Planning and Zoning Commission Meeting

Aubrey City Council Chambers
226 Countryside Dr.
Aubrey, TX 76227
December 12, 2024
6:00 PM

1. Consider and make a recommendation to City Council regarding a Preliminary Plat application for Highpointe Ranch Phase 2 containing 219 residential lots and two (2) HOA/nonresidential lots in approximately 38.154 acres of land out of the F. Trevino Survey, Abstract No. 1243, City of Aubrey, Denton County, Texas. *(KLB Buy 3, LLC)*

**Planning and Zoning Commission Meeting
Staff Report
December 12, 2024**

Sheet No.
2 OF 3

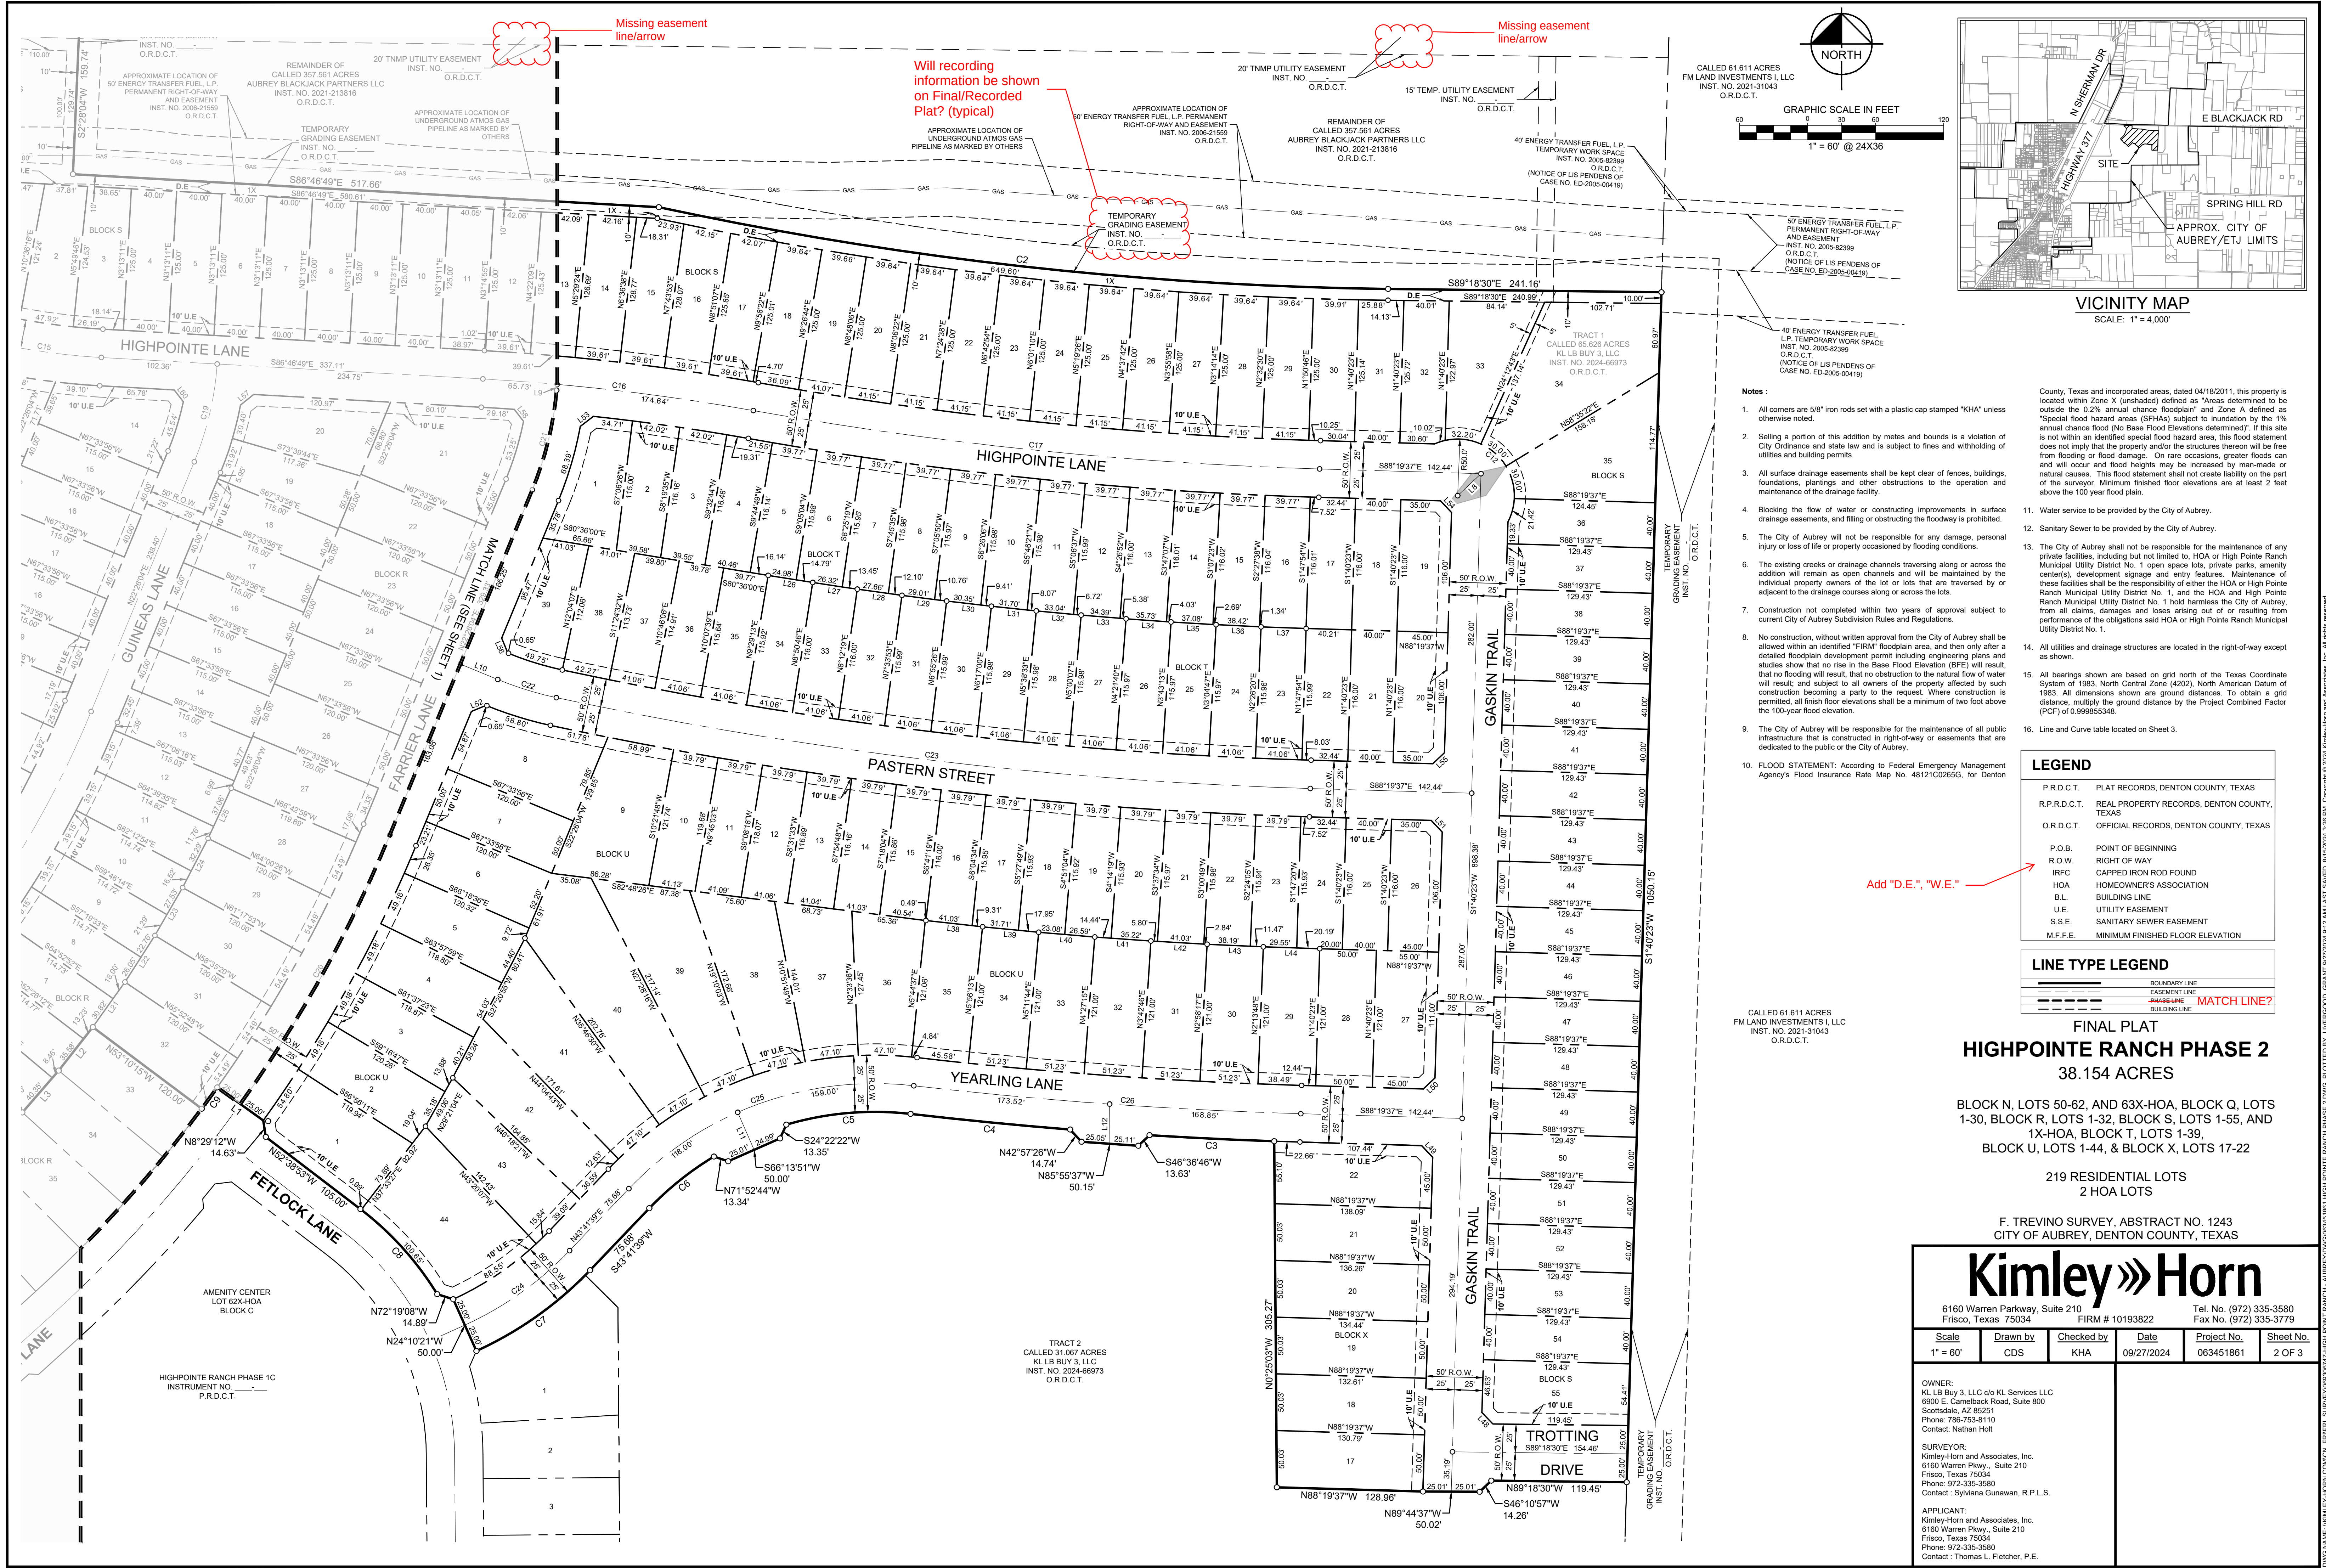
Add "D.E.", "W.E."

Scale	Drawn by	Checked by	Date	Project No.	Sheet No.
1" = 60'	CDS	KHA	09/27/2024	063451861	1 OF 3

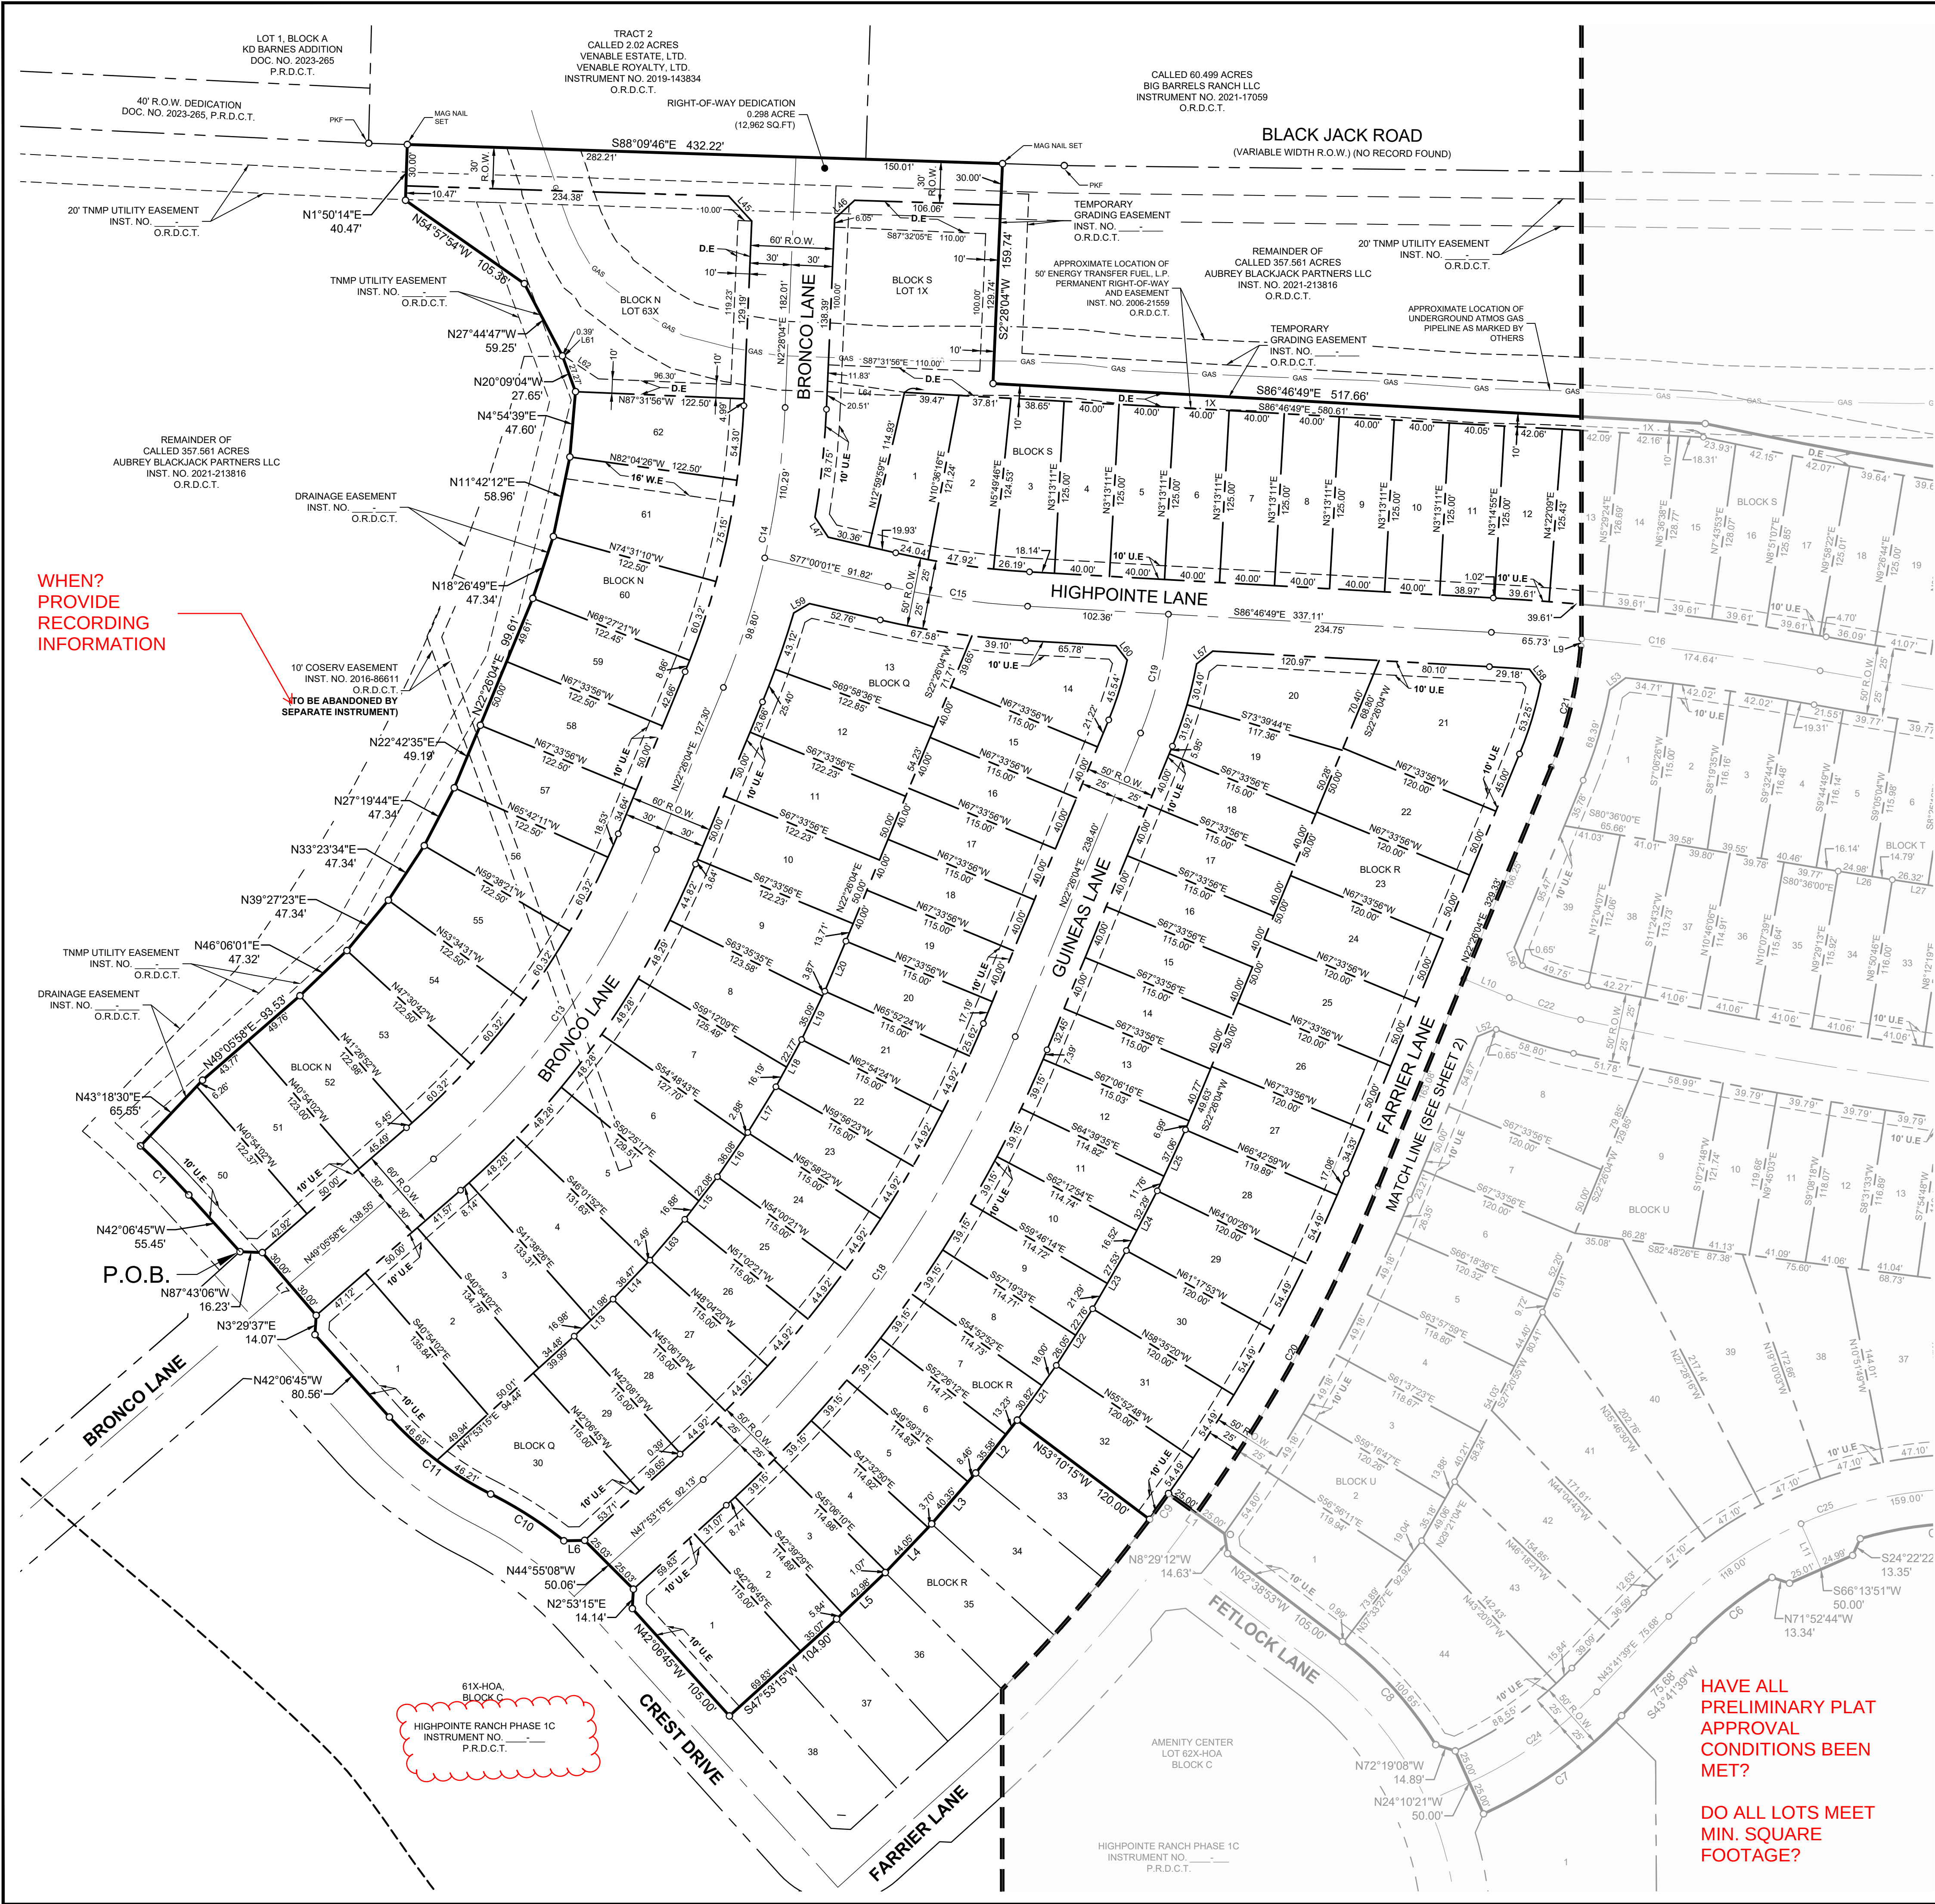
ADD BUILDING LINES
